Final SEIS - Mauna Lani Cove
Determination of Acceptability

F I N A L RECEIVED
 SUPPLEMENTAL
 ENVIRONMENTAL
 I M P A C T
 STATEMENT

MAUNA LANI COVE

MAUNA LANI RESORT
SOUTH KOHALA, HAWAII

Figure II-3
CONCEPT PLAN
MAUNA LANI COVE
Mauna Lani Resort
South Kohala, Hawaii

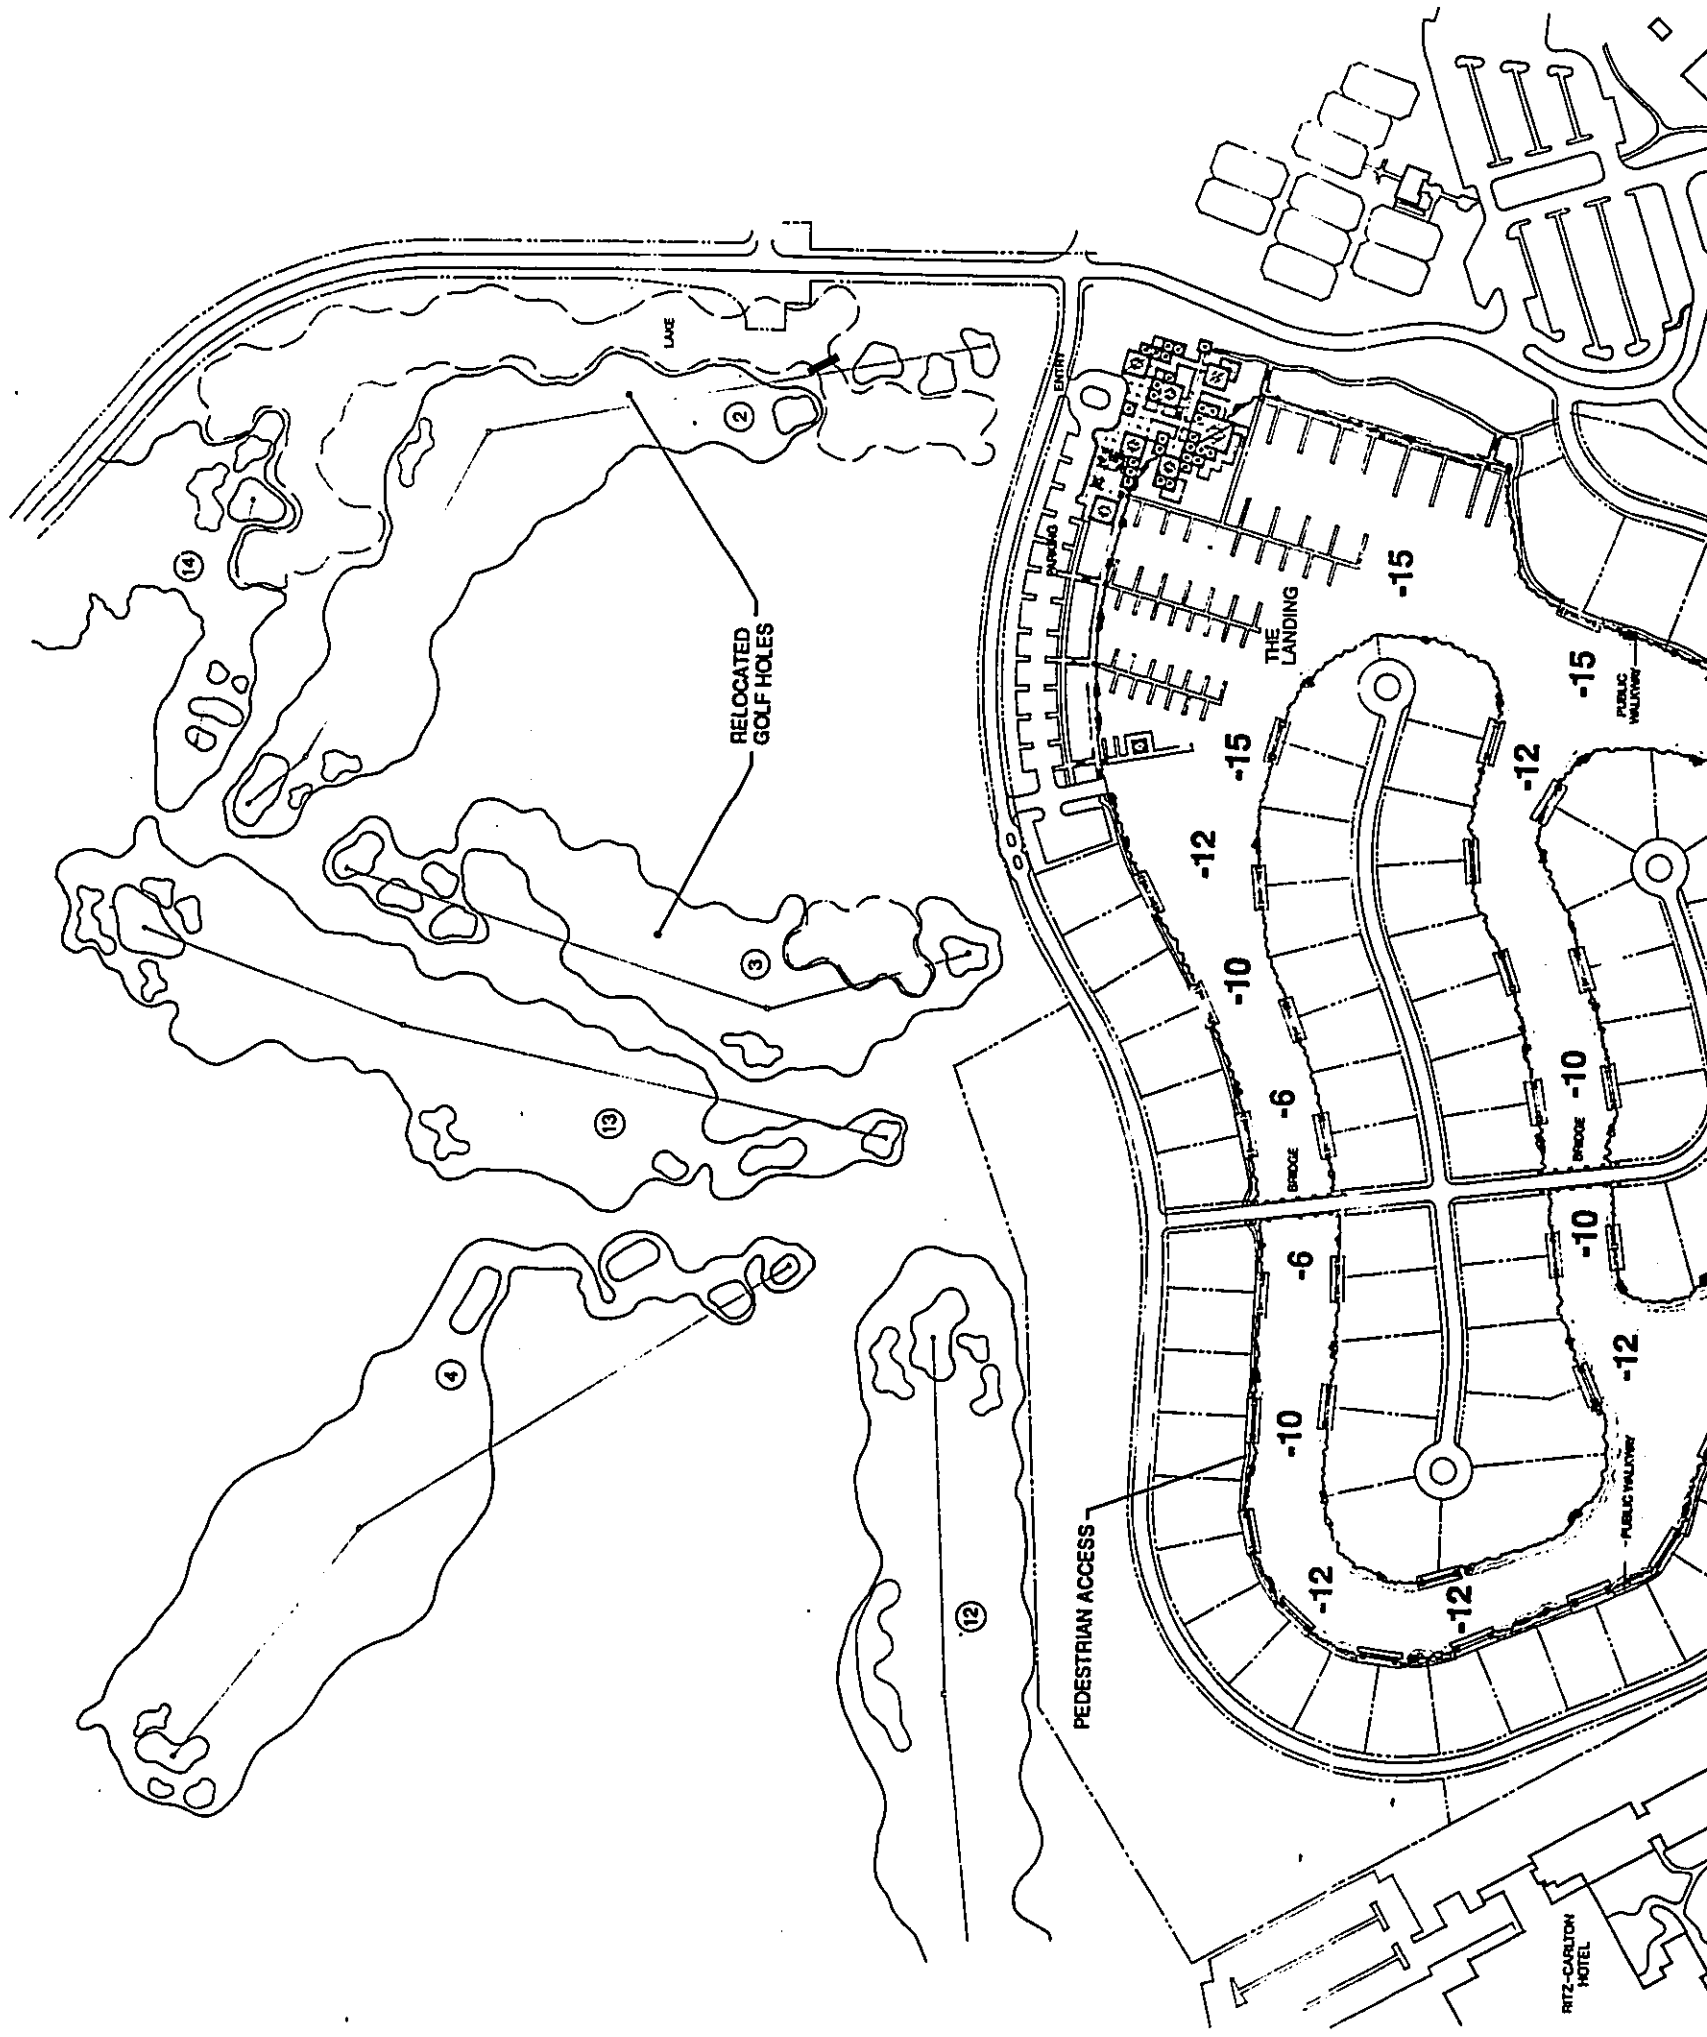
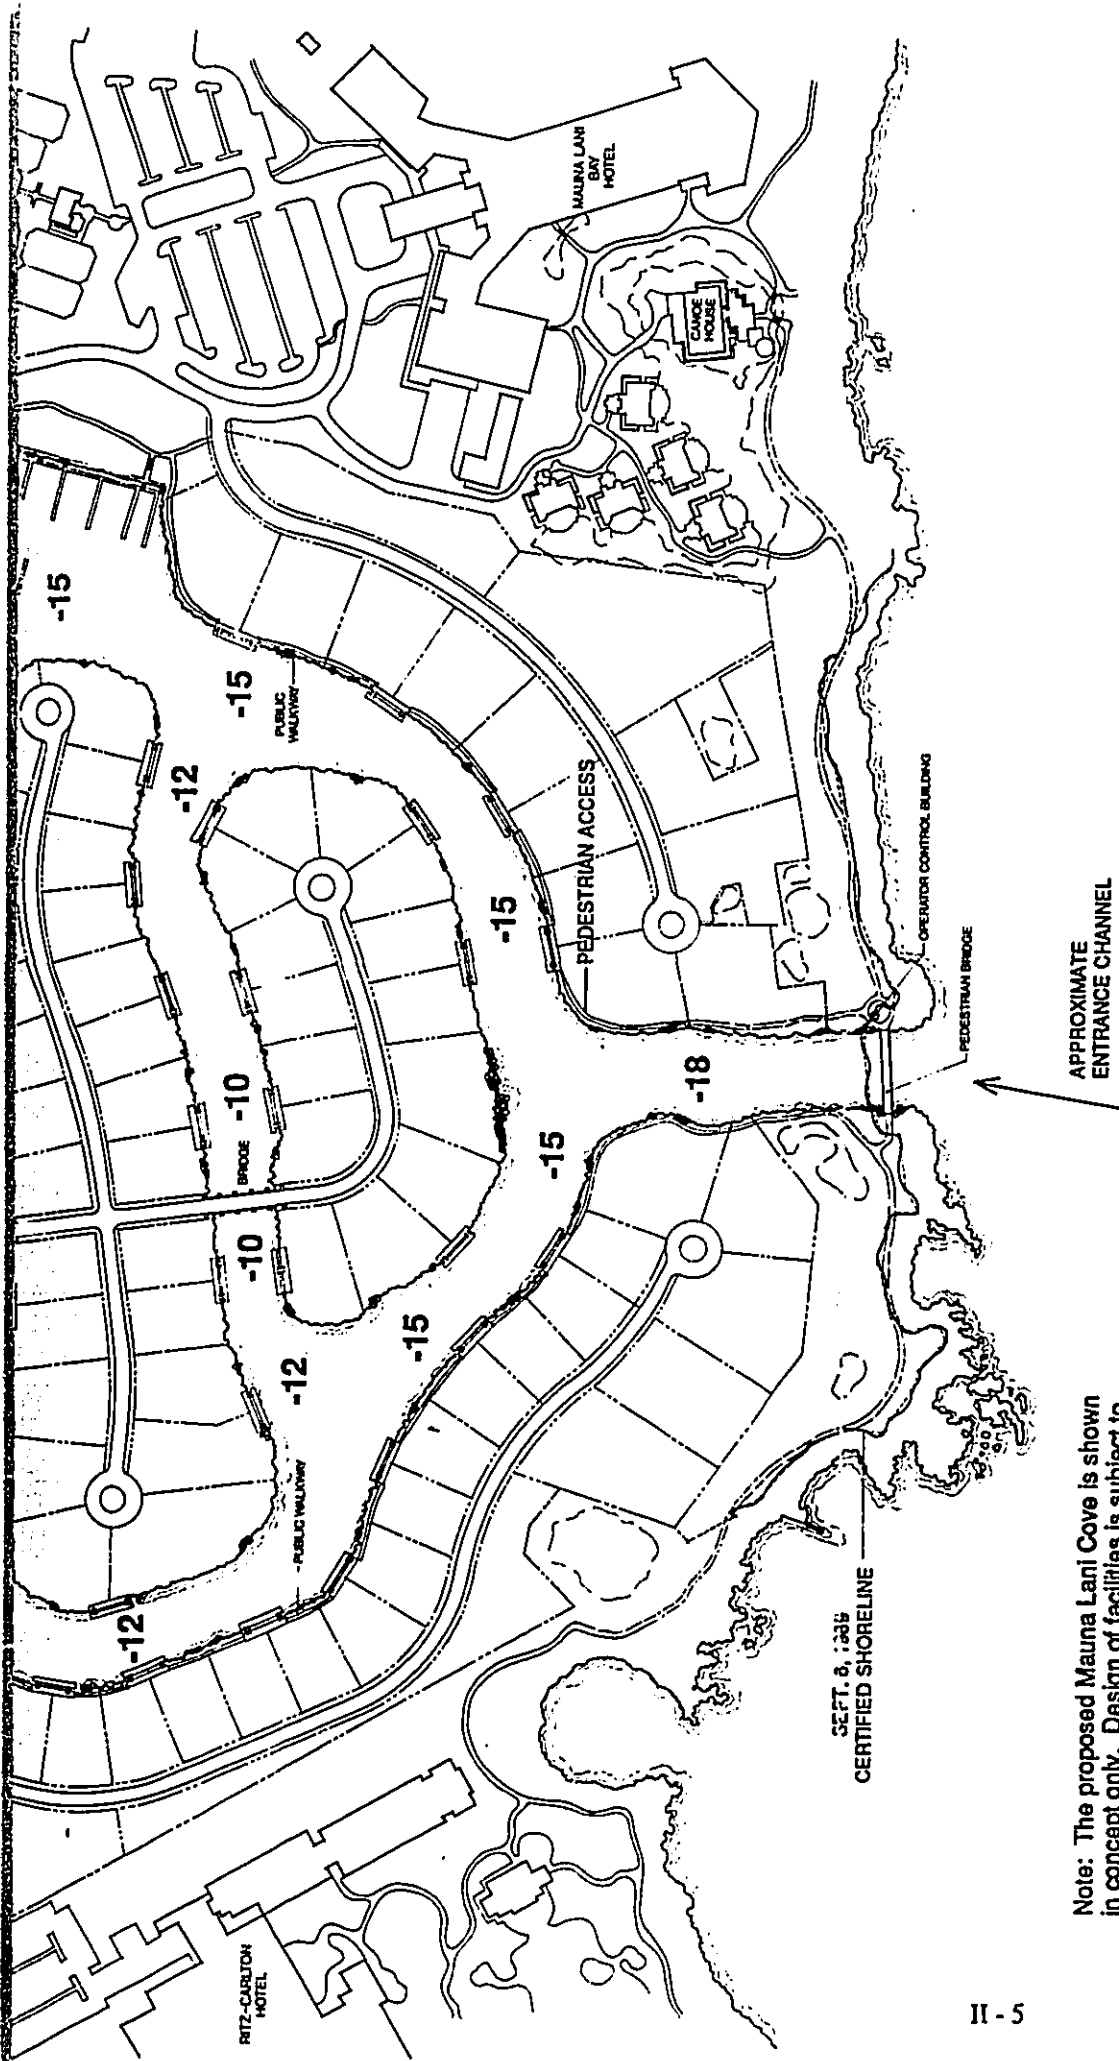
3. The document needs to clarify if the area of the proposed clustered single family detached units will be subdivided. Figure II-2 (Master Plan) appears to be proposed lots, however Figure II-3 (Concept Plan) does not show this. Are the interior channelways considered to be one lot and what are the plans for ownership?

Reference is made to figure II-3 on page II-3 in the "Mauna Lani Cove" EIS titled "Concept Plan". Attached to this EIS submittal is an altered figure II-3 indicating PASH's "Proposed Easements" and realignment of the shoreland enclave at "Mauna Lani Park".

Figure IV-11
**BATHYMETRY AND AREA
 OF EXCAVATION**
MAUNA LANI COVE
 Mauna Lani Resort
 South Kohala, Hawaii

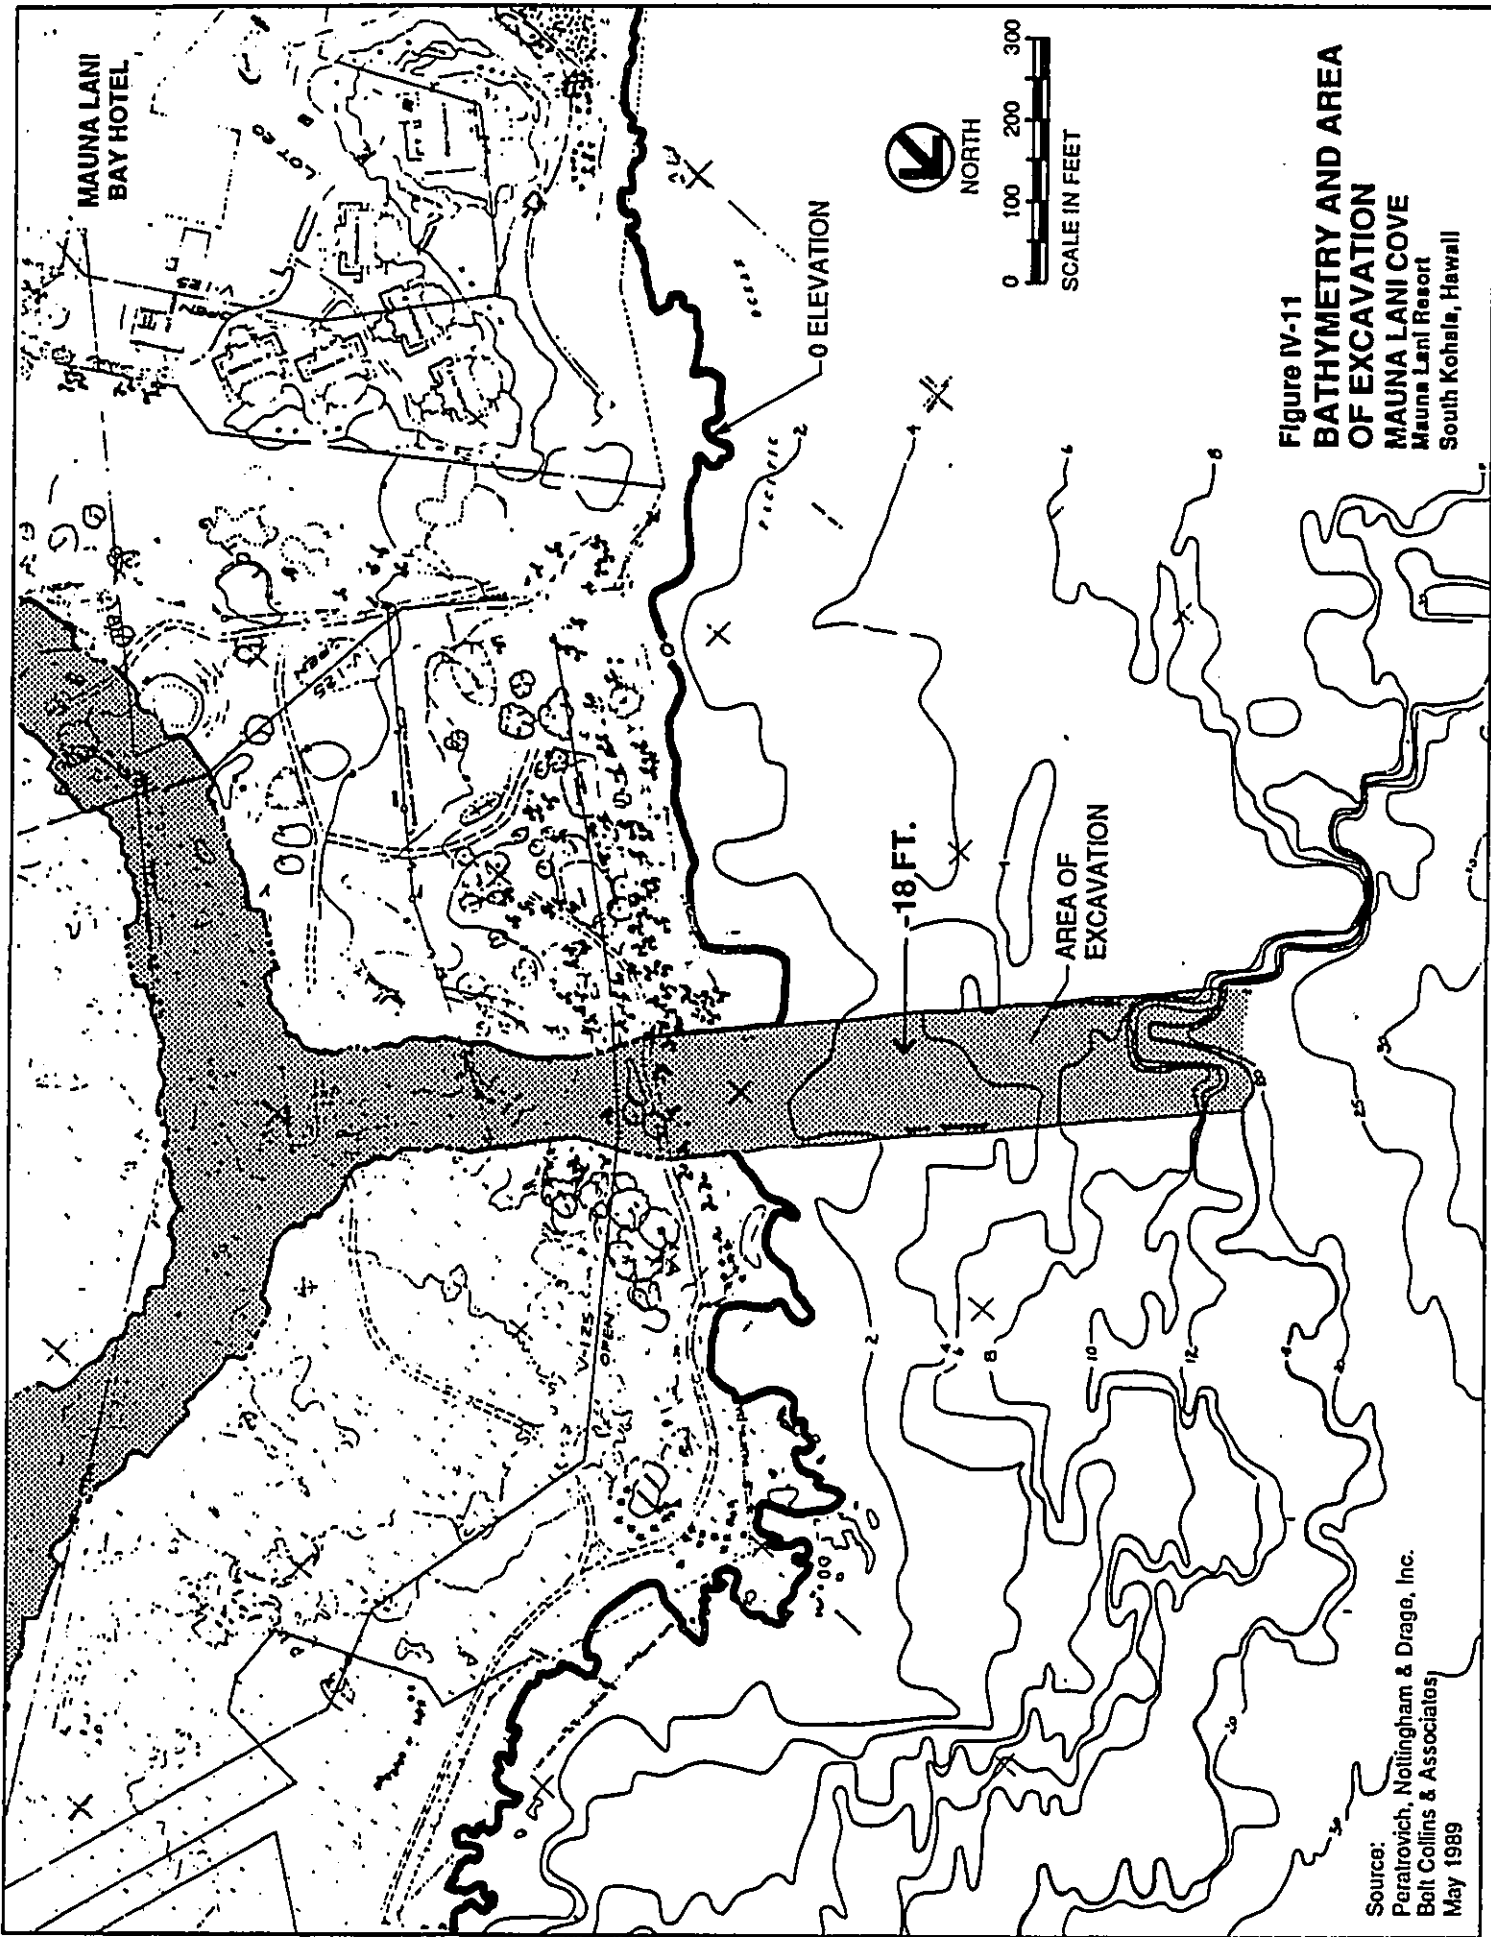
30. The Ritz-Carlton Final EIS (Figure IV-11) reflects a roadway which branches off into the project site. The SEIS did not address the alternative use or status of this roadway system.

30. Figure IV-11 of the Draft Supplemental EIS is in error and will be corrected in the Final Supplemental EIS. The short roadway branch will not be constructed and will be deleted from the figure.
